# MONITORING YEAR 4 ANNUAL REPORT

## OWL'S DEN MITIGATION SITE

RE: Owl's Den Mitigation Site-Year 4 Monitoring Report  
Final Submittal for DMS  
Contract Number 004673, RFP Number 16-004110, DMS# 95360  
Yadkin River Basin – CU# 03040105; Union County, NC

Wildlands Engineering, Inc. (Wildlands) has reviewed the Division of Mitigation Services (DMS) comments and observations from the Owl's Den Mitigation Site Draft Year 4 Monitoring Report. Wildlands walked the site on 1/7/2019 to evaluate the site condition after the beaver dam was removed. Wildlands confirmed that the streams are stable and that monitoring features have not impacted by the beaver dam. The report text has been revised for the final draft to reflect the most current condition of the site. The following are Wildlands responses to your comments and observations from the report noted in italics lettering.

Figure 2 Project Component/Asset Map  
 Owl's Den Mitigation Site  
 DMS Project No. 95808  
 Monitoring Year 4 - 2019  
 Lincoln County, NC

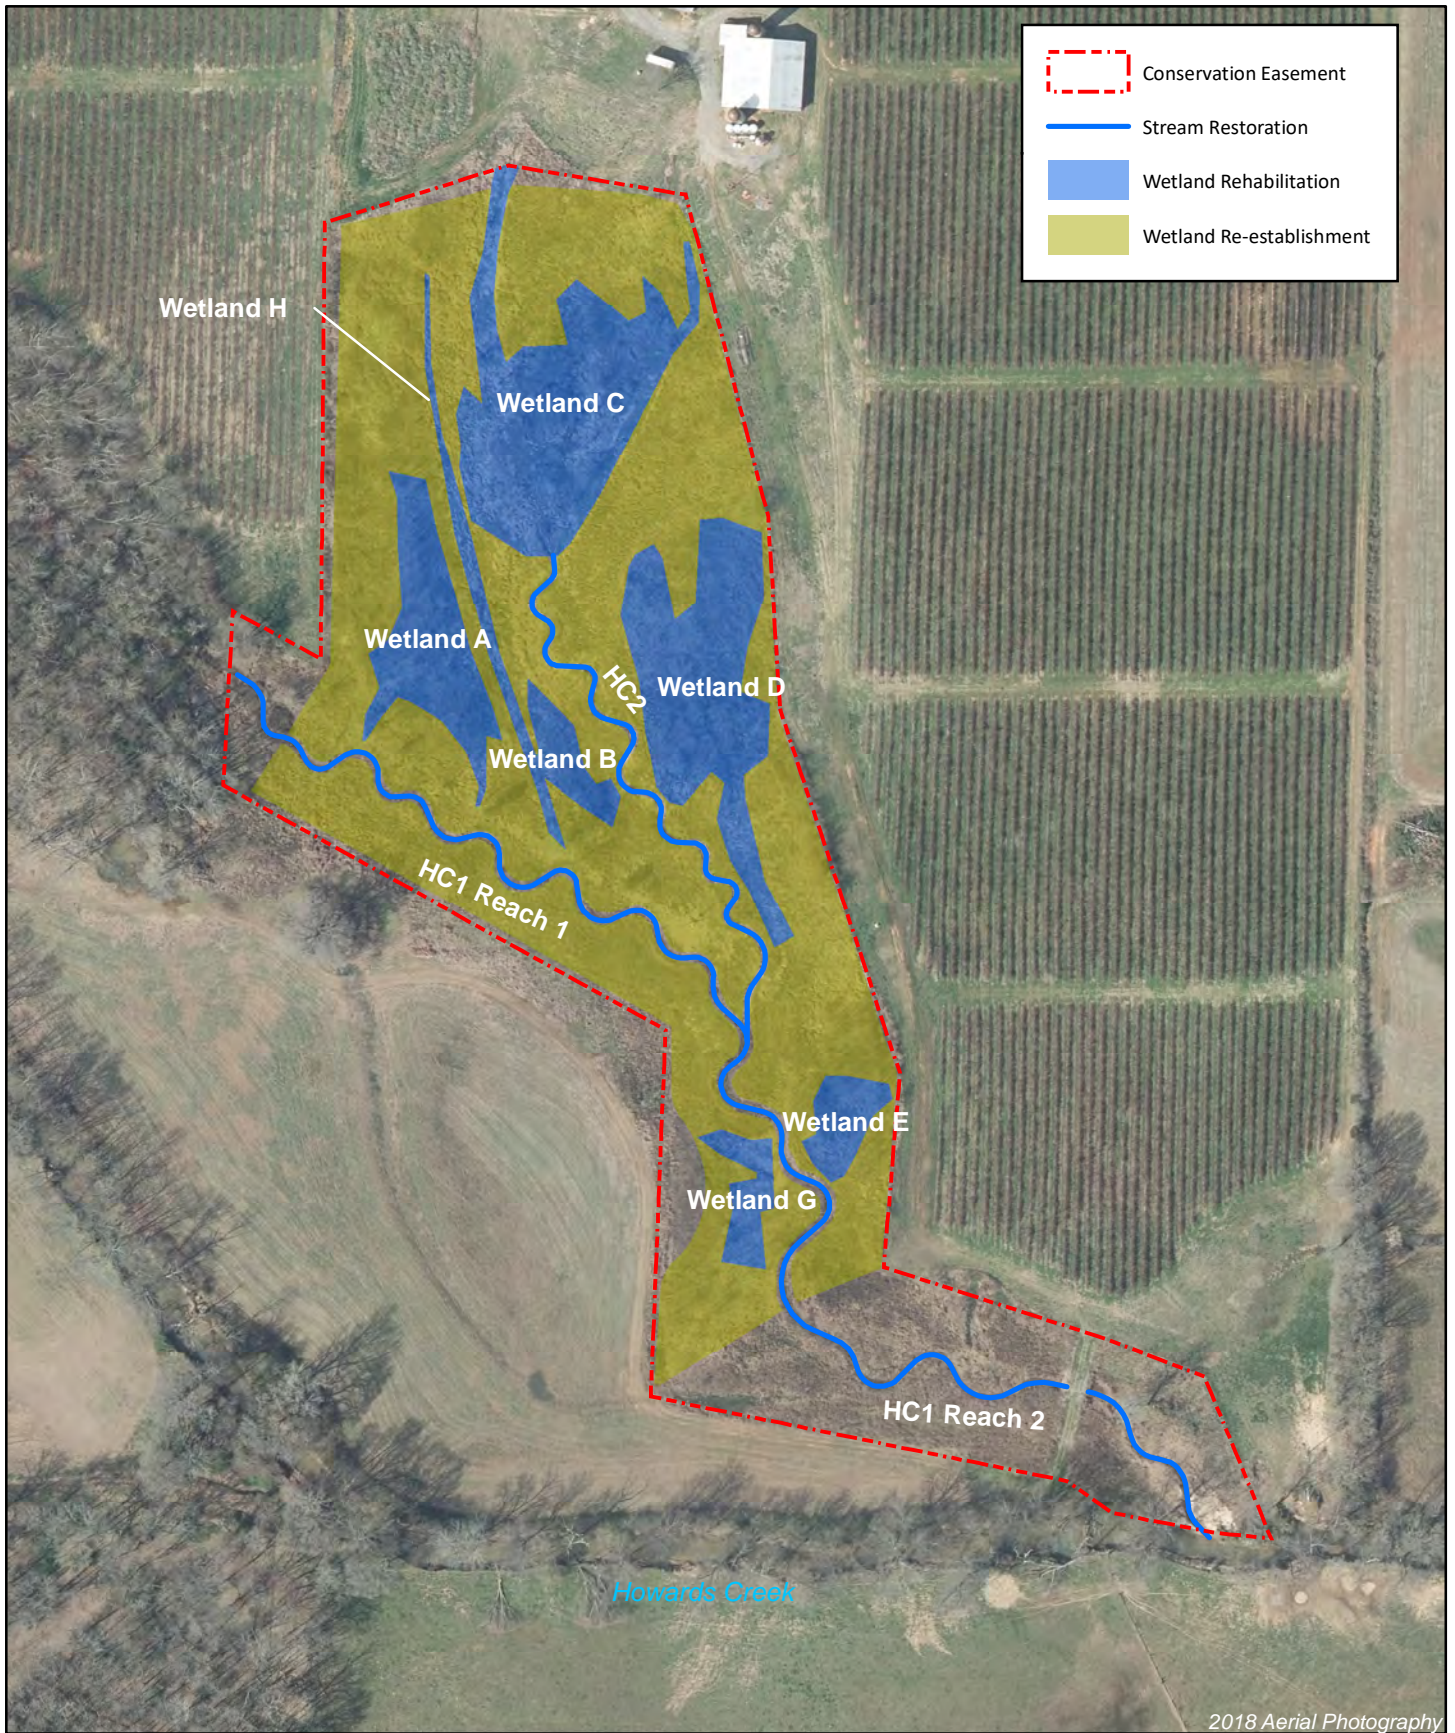
**DMS Comment: The Wetland Re-Establishment and HC1 Reach 2 geodatabase features do not match reported assets. DMS needs geospatial features that accurately characterize creditable assets. Please update the report and digital support files accordingly.**

*Wildlands Response; The Wetland Re-Establishment and HC1 Reach 2 geodatabase features and the corresponding figures have been updated. The report and the digital support files have been updated accordingly.*

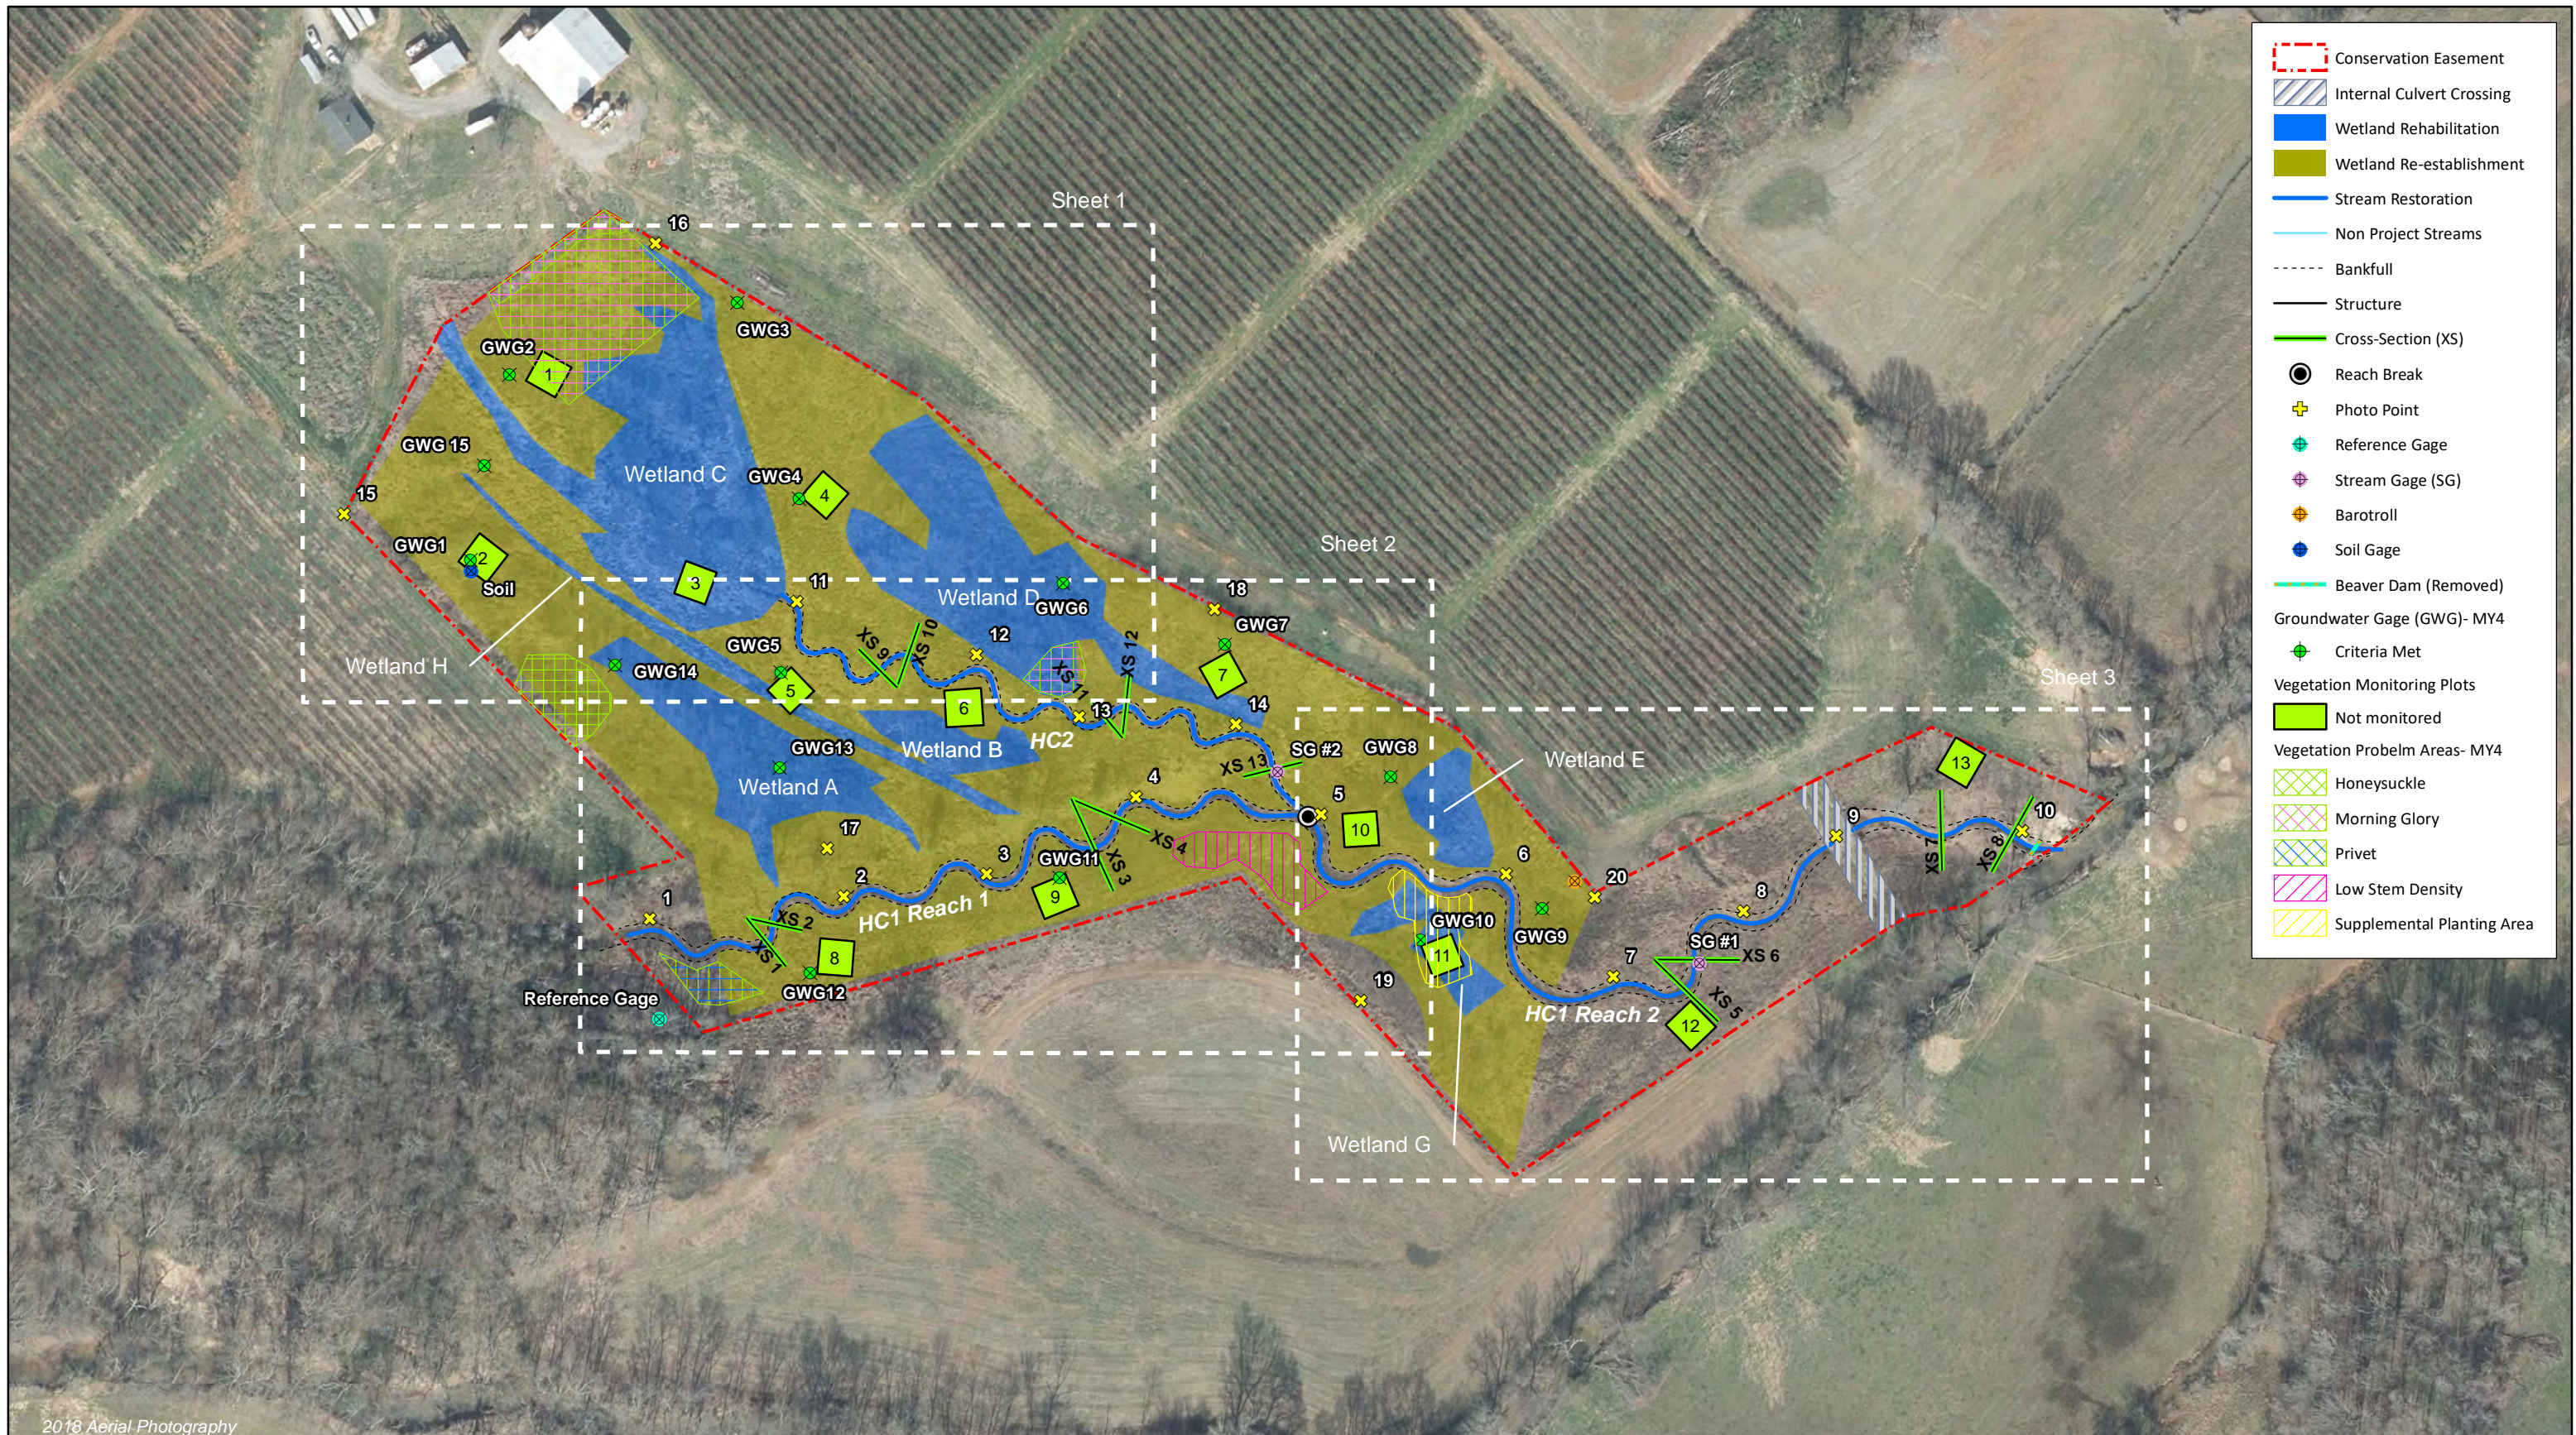
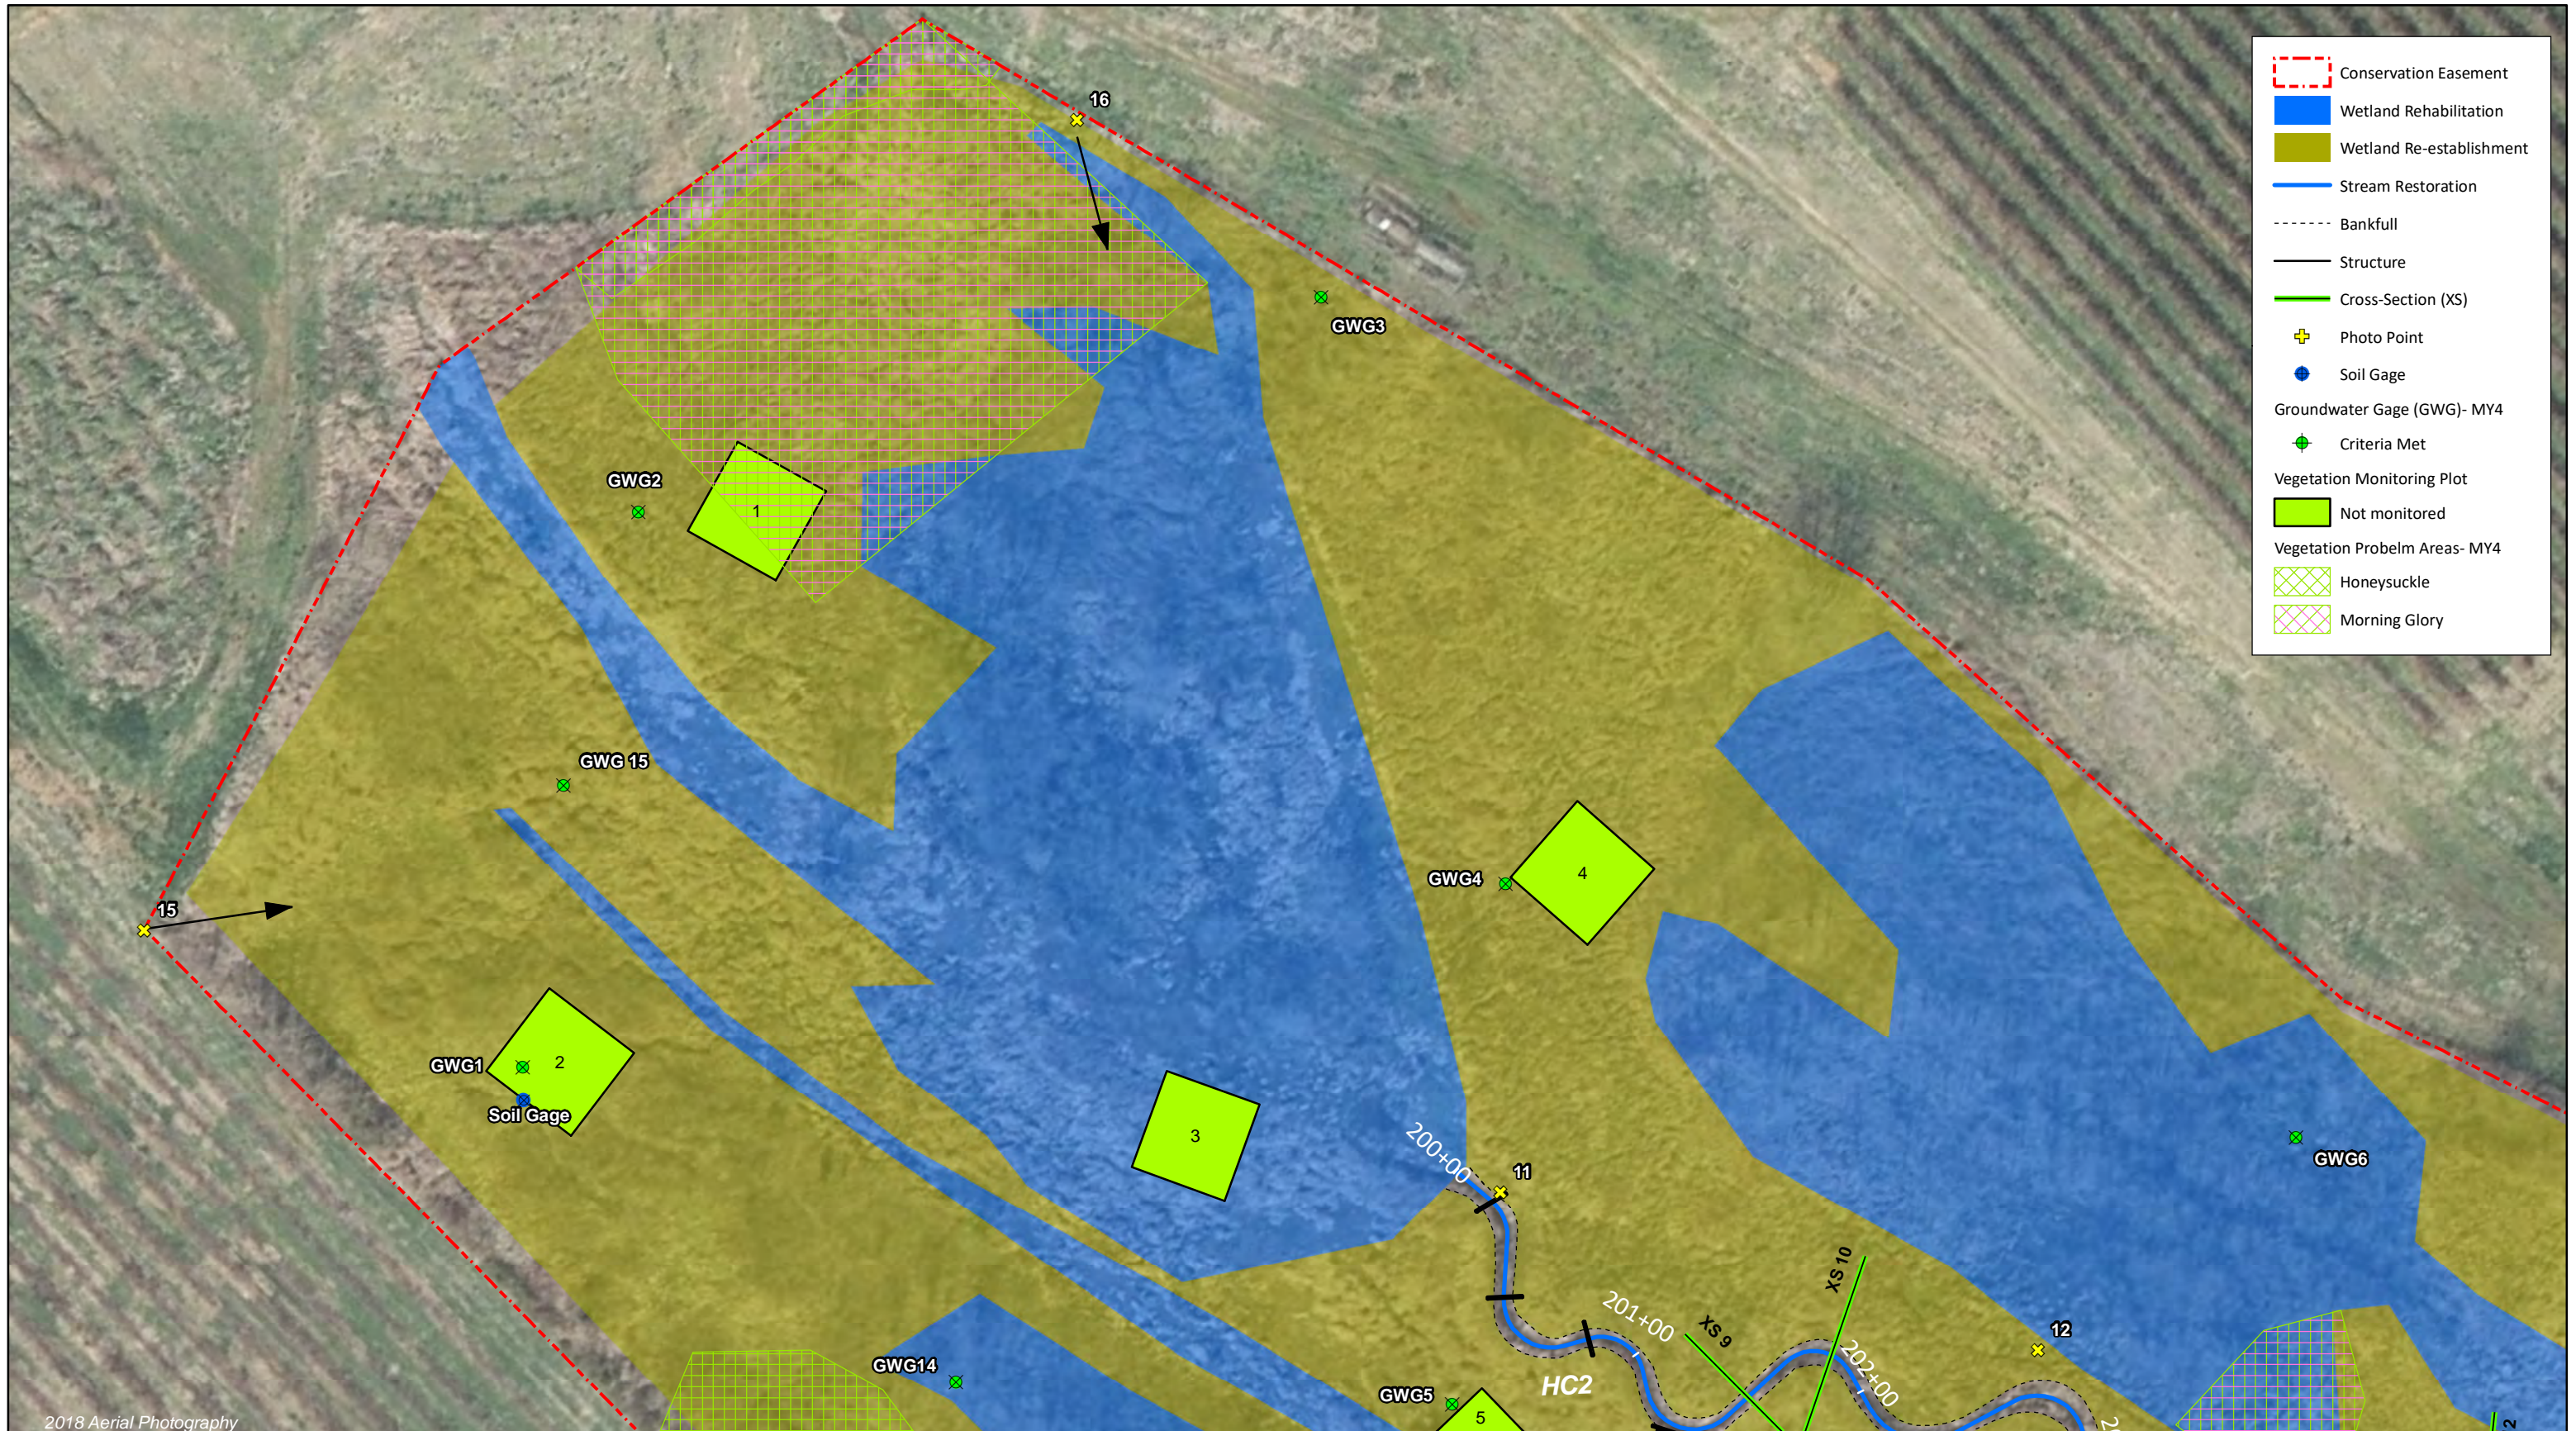
**DMS Comment; Section 1.2.3; Please show and identify the March 2019 replant area on the revised CCPV maps. In the report verbiage, please also identify the approximate number of plants installed. Please QA/QC this section for grammar errors/ run-on sentences.**

*Wildlands Response; The CCPV maps have been updated to include the supplemental planting area. The approximate number of plants installed have been added to the report text. The report text was reviewed for grammar errors/ run-on sentences.*
